Product Change Notification / CENO-280WHW230

CCB 6054 Final Notice: Implement top marking changes for WBZ451PE-I and WBZ451UE-I catalog part numbers (CPN) available in 39L Module (15.5x20.7mm) package.

CCB 6054
Pre and Post Change Summary
PCN #: CENO-280WHW230

MARKING CHANGE SUMMARY

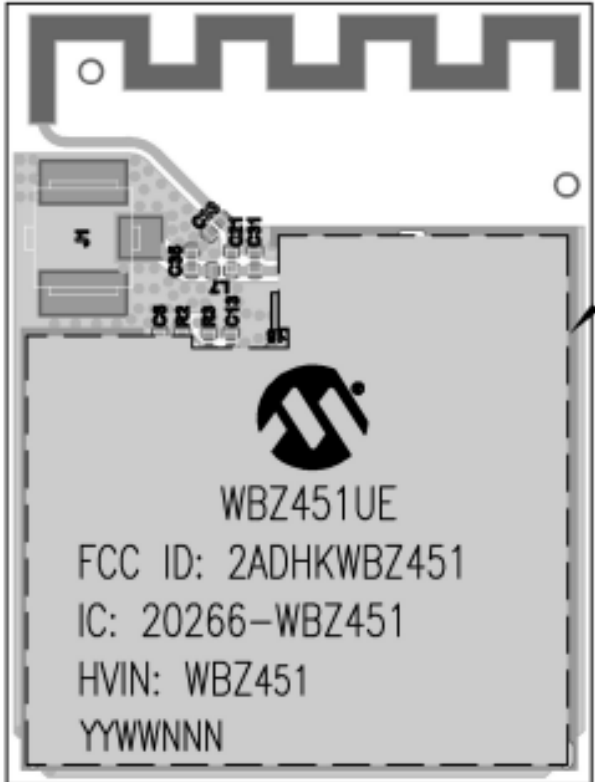
Pre Change	Post Change
WBZ451PE-I	 <p>WBZ451PE FCC ID: 2ADHKWBZ451 IC: 20266-WBZ451 HVIN: WBZ451 YYWWNNN</p>	 <p>WBZ451PE FCC ID: 2ADHKWBZ451 IC: 20266-WBZ451 YYWWNNN</p> <ul style="list-style-type: none">- Removing Line5 marking HVIN: WBZ451- Line6 marking YYWWNNN will move up to line 5 position

MARKING CHANGE SUMMARY

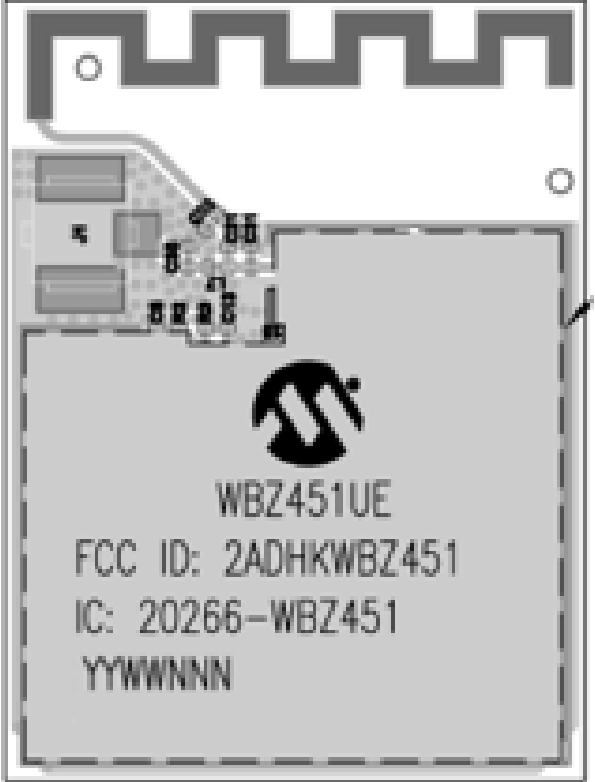
Pre Change	Post Change
WBZ451UE-I	 <p>WBZ451UE FCC ID: 2ADHKWBZ451 IC: 20266-WBZ451 HVIN: WBZ451 YYWWNNN</p>	 <p>WBZ451UE FCC ID: 2ADHKWBZ451 IC: 20266-WBZ451 YYWWNNN</p> <ul style="list-style-type: none">- Removing Line5 marking HVIN: WBZ451- Line6 marking YYWWNNN will move up to line 5 position
